PROPOSAL:

- **Rezoning** from RF to RF-13
- **Development Variance Permit**

LOCATION: 16527 - 84 Avenue

LAND DEVELOPMENT ENGINEERING REVIEW

The applicant is proposing to rezone from RF to RF-13 and proposing a subdivision from one(1) to three(3) lots as shown on the Preliminary Layout Plan provided by Mainland Engineering Design Corporation, Drawing No. 1, dated February 1, 2023.

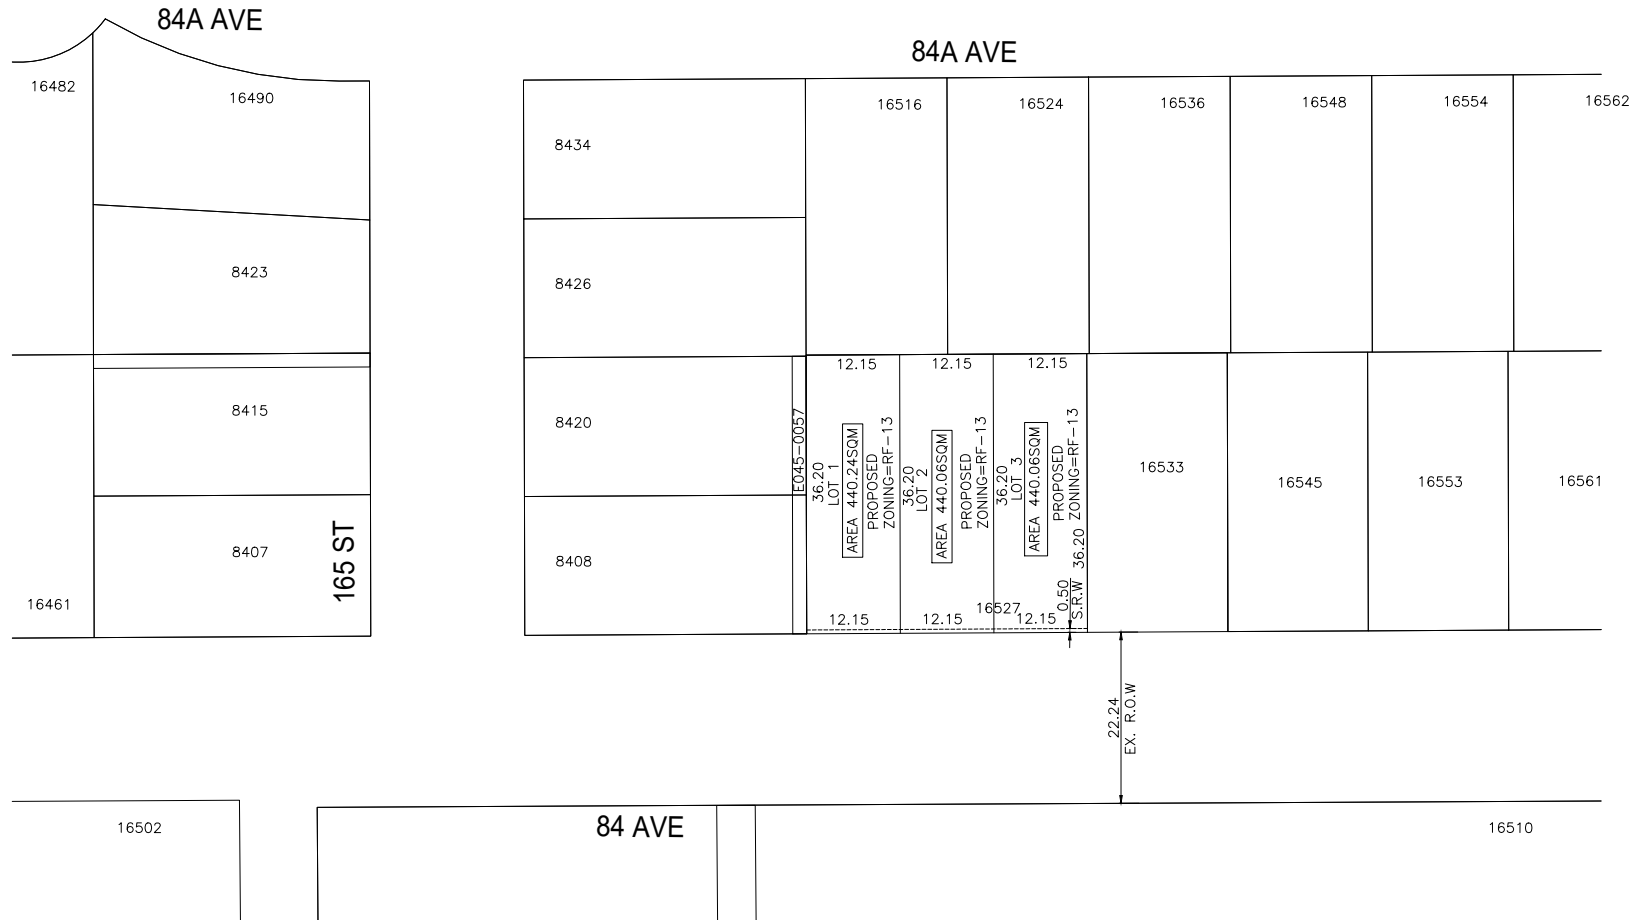
The following road right-of-way dedication, as illustrated on the marked up Preliminary Layout Plan attached, is required for existing road fronting the site:

- Register 0.5m statutory right of way for maintenance.

The applicant should address all road dedication and rights-of-way issues prior to finalizing layout or commencing legal survey or detailed design.
